September 23, 2012
LHC Project File: 1218

Re: Proposed SIA Contaminated Soils Landfill, Stebbings Road, Malahat Land District, BC

As discussed in our July meeting we have reviewed the South Island Aggregates (SIA) proposal for a Contaminated Soils Landfill at the above noted site. Information regarding the landfill development has been obtained from the SIA website. A preliminary assessment of the proposed landfill site and its suitability for the intended purpose has been carried out utilizing existing information. Several environmental and human health risks regarding the landfill have been identified. Our investigations are focused on the site hydrogeology and potential for negative impacts on the local groundwater flow system and those dependant on this system for their drinking water.

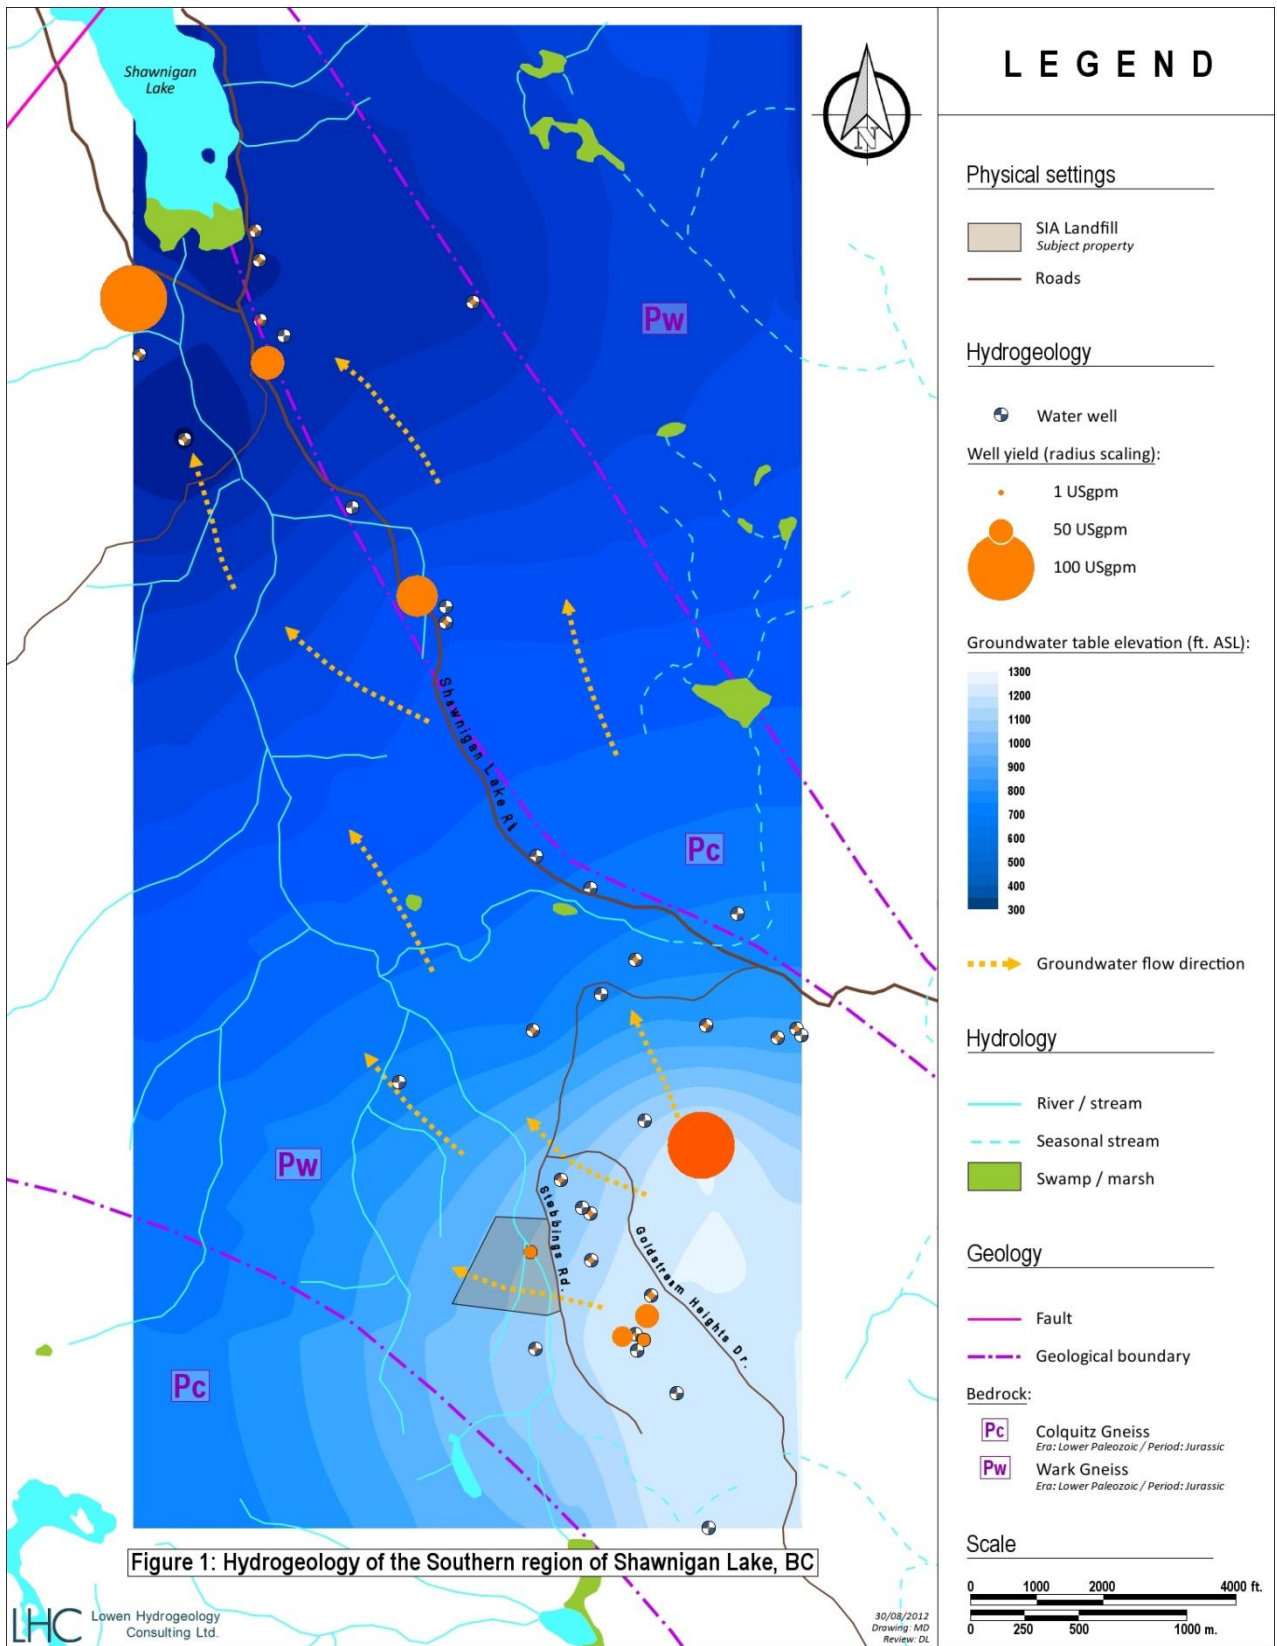
Rainfall that infiltrates the ground at the subject site will flow downward to the aquifer and then flow toward the northwest (toward Shawnigan Lake). See Figure 1 for a graphic representation of the groundwater flow system.

The water table slope from the proposed landfill site to the lake is 0.05. This slope provides a good driving head to propel groundwater from the site to the lake. The groundwater velocity from the landfill site to the lake is estimated at 5 - 10 m/d. Therefore the 5 Km distance would be traversed within 1.4 to 2.7 years. Any contamination carried by the groundwater flow would reach the lake with little attenuation. There would be little adsorption or filtration in open bedrock fractures and only dilution would reduce contaminant concentrations. Dilution alone may not be enough to prevent contamination of lake water.
